Detailed Site Plan Capitol Heights Shopping Center

DSP-06015-01

STAFF REPORT

SUBJECT: Detailed Site Plan DSP-06015-01
Type II Tree Conservation Plan TCPII-009-09-01
Capitol Heights Shopping Center

Figure 3: Front, Rear and Side Architectural Elevations of Giant

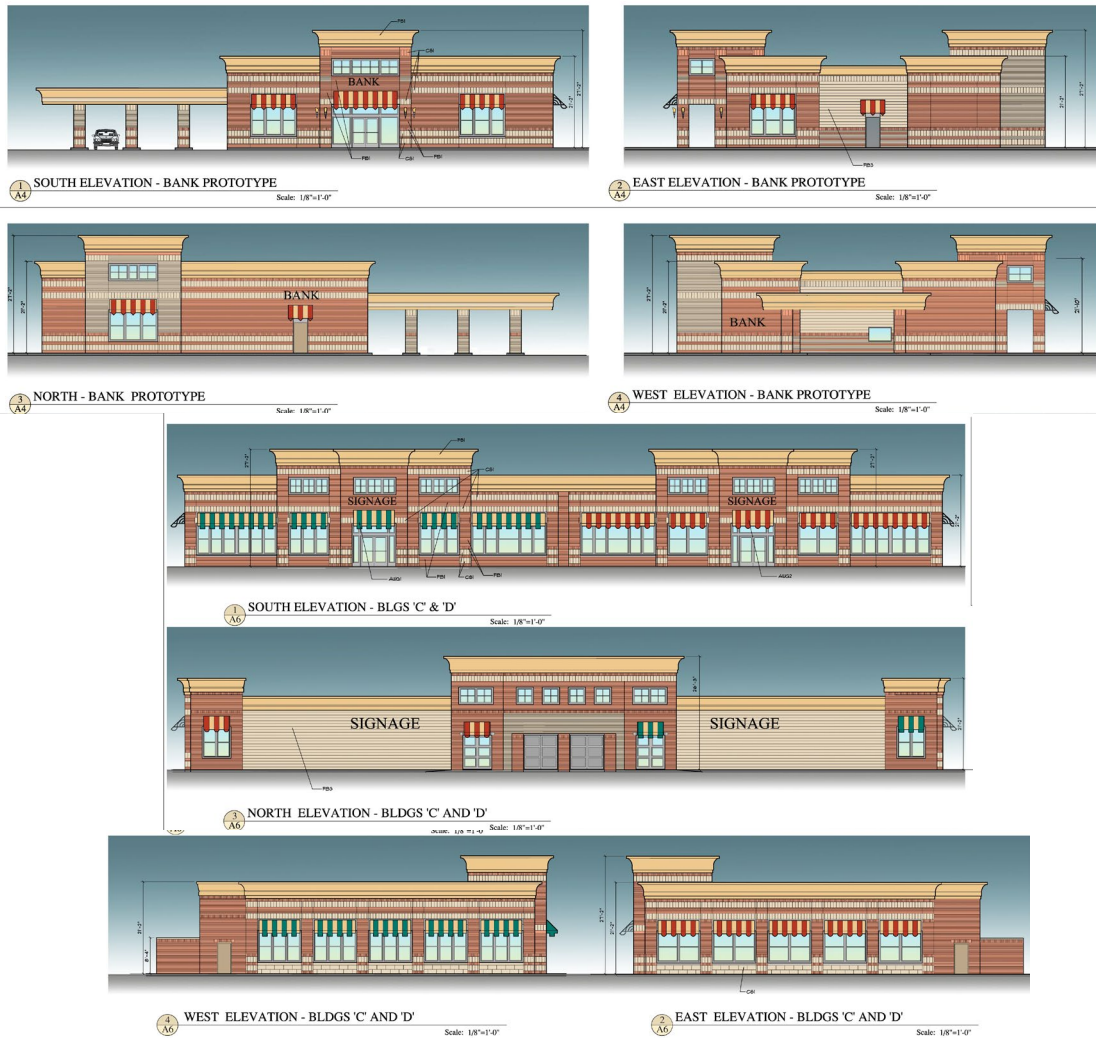
Even though the sector plan specifically required a national chain store be placed on this site and the applicant responded by providing a Giant grocery store, the Giant building is not typical franchise architecture. As discussed above, the Planning Board previously found that the EIFS as shown on the elevation is acceptable and approved the applicant's amendment request.

1. Prior to certificate approval of this detailed site plan (DSP), the applicant shall:
 - a. Provide spandrel glass window treatments in the current block pattern locations along Giant's front elevations to meet the minimum 40 percent display window requirement; provide a porch along the front elevation of the Giant building with all changes to be reviewed and approved by the Urban Design Section as the designee of the Prince George's County Planning Board.
